[Docket No. 99-NM-76-AD; Amendment 39-11540; AD 2000-02-22]

Airworthiness Directives; Boeing Model 747-400 Series Airplanes Equipped with Rolls-Royce RB211-524G/H and RB211-524G-T/H-T Engines

ACTION: Final rule; request for comments.

Lock Bar/Load Tool Installation and Gearbox Manual Lock Release
Figure 1

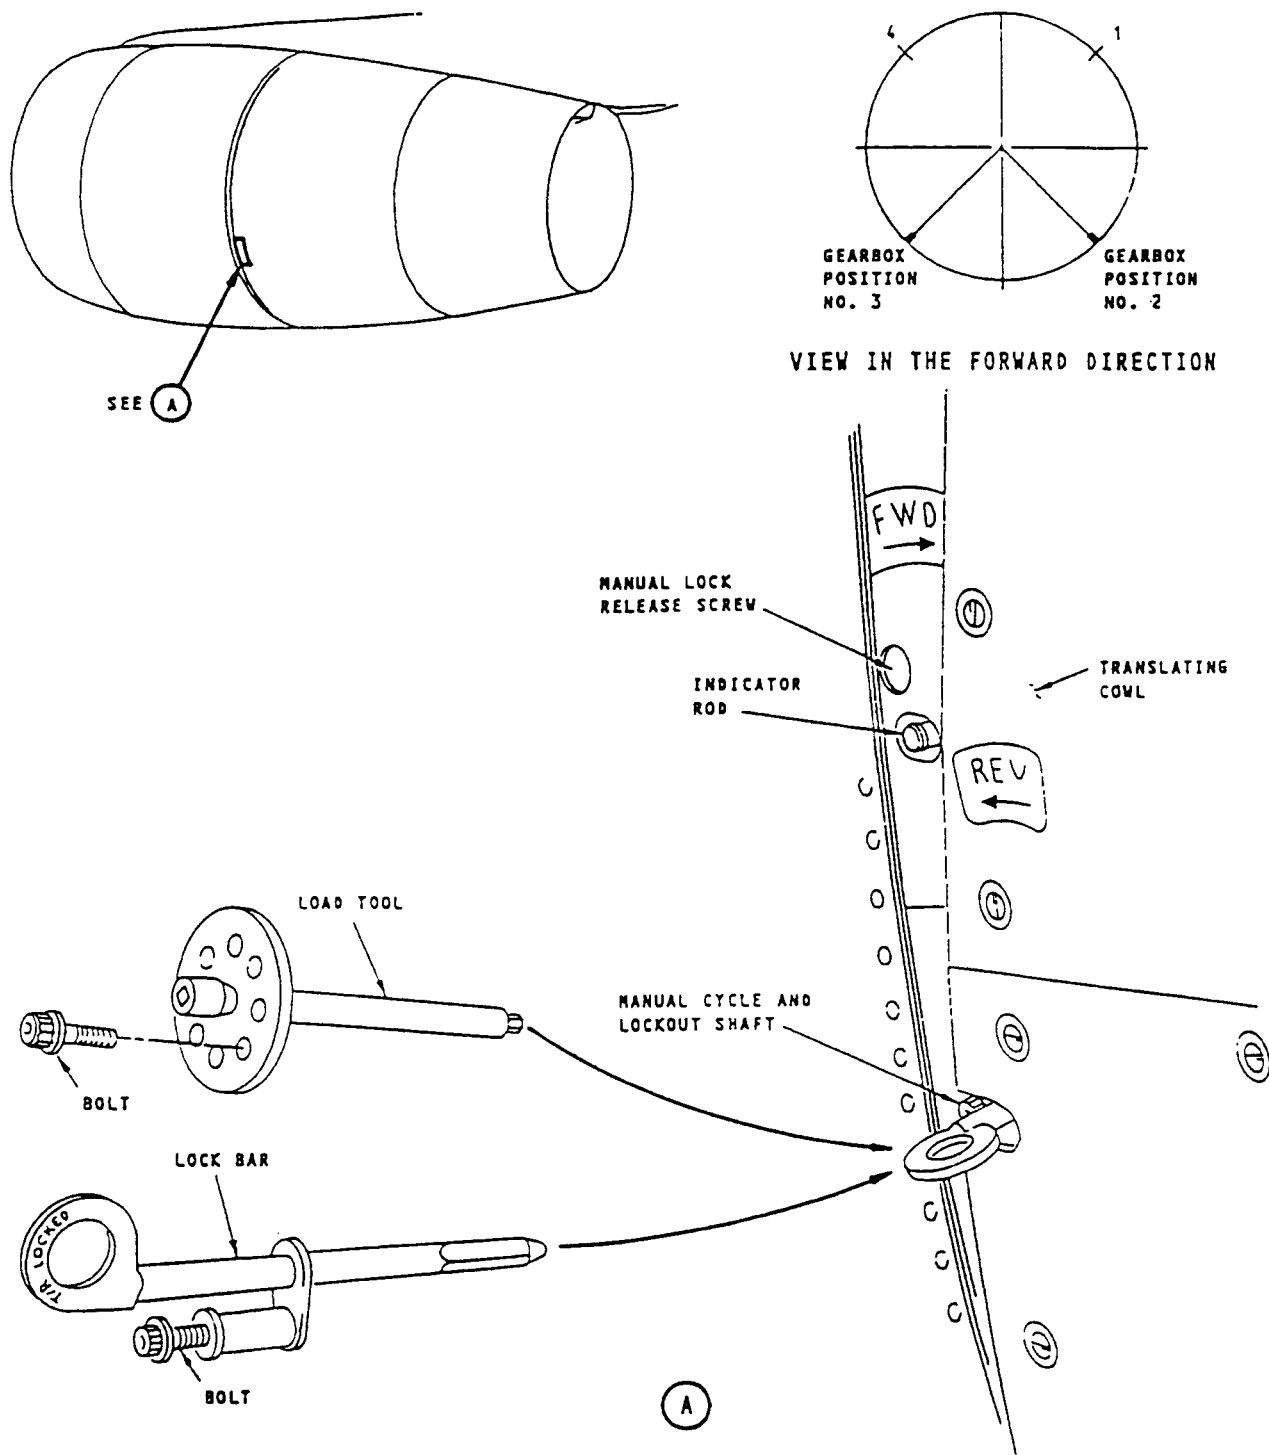
Repetitive operational checks to detect discrepancies of the gearbox locks and the air motor brake are required to be accomplished in accordance with procedure included in Appendix 1 (including Figure 1) of this AD. Correction of any discrepancy detected is required to be accomplished in accordance with the procedures described in the Boeing 747 Airplane Maintenance Manual.

(c) If any operational check required by paragraph (b) of this AD cannot be successfully performed as specified in the procedures described in Appendix 1 (including Figure 1) of this AD, or if any discrepancy is detected during any operational check, prior to further flight, repair in accordance with the procedures specified in the Boeing 747 Airplane Maintenance Manual. Additionally, prior to further flight, any failed operational check required by paragraph (b) of this AD must be

C. Procedure (Fig. 1).

(2) Use a 0.25 inch (6.4 mm) square drive to turn the manual lock release screw to release the No. 2 and No. 3 gearbox locks.

(4) Do a test of the gear box locks:

NOTE: GEARBOX POSITION NO. 3 IS SHOWN.
GEARBOX POSITION NO. 2 IS THE SAME.
